5-1– 12

Proposed Change as Submitted

Proponent: Kim Paarlberg, International Code Council

Committee Action

Fig. 504.2
Treads and Risers for Accessible Stairways

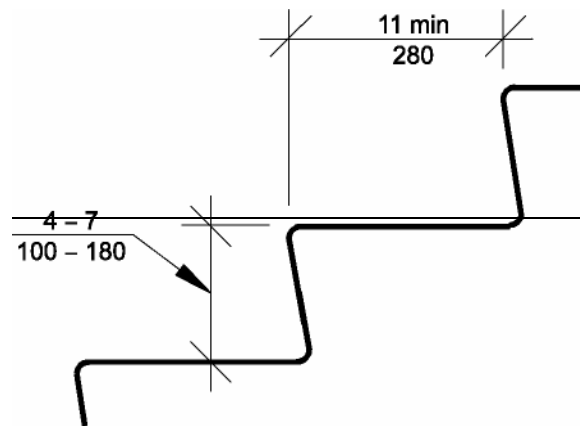
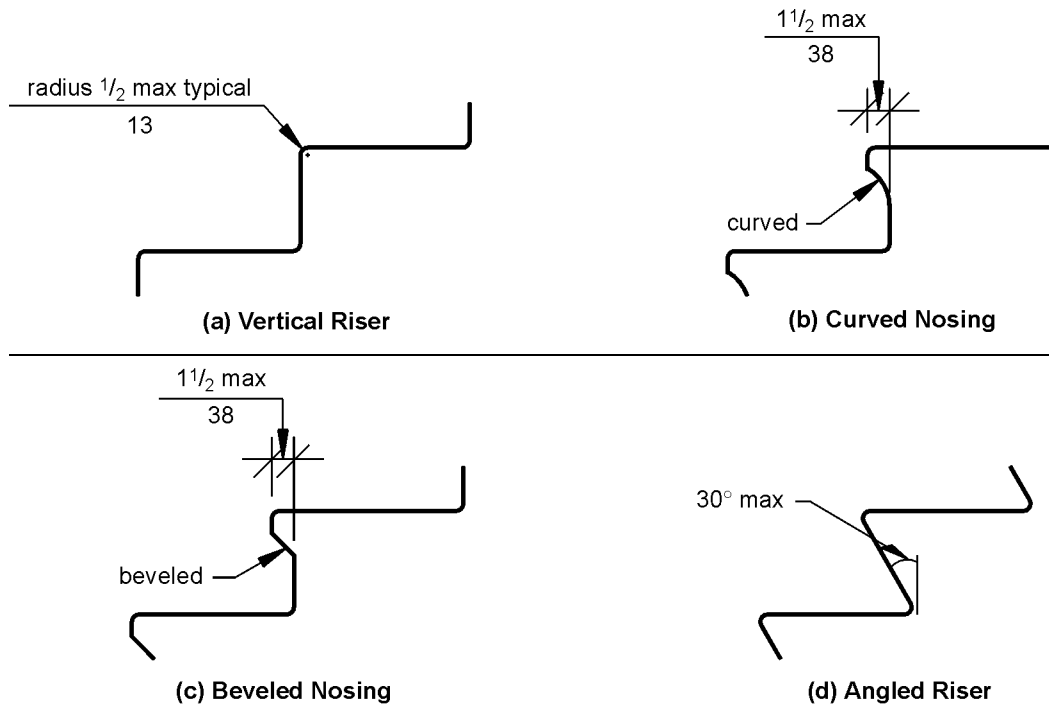
Reason: These requirements are in International Building Code Section 1009. Stairs are not considered an accessible route of travel under the 2009 International Building Code, Chapter 11 or ICC/ANSI A117.1, Chapter 4.

Committee Reason: The proposal is inappropriate for two key reasons: 1. The Standard contains provisions for stairways which are not found in the IBC; deleting these provisions would eliminate those additional requirements. 2. IBC is not the only document which could be used to reference the A117.1; if the other referenced standard do not have adequate stairway provisions, again deleting such from the Standard would be a disservice.
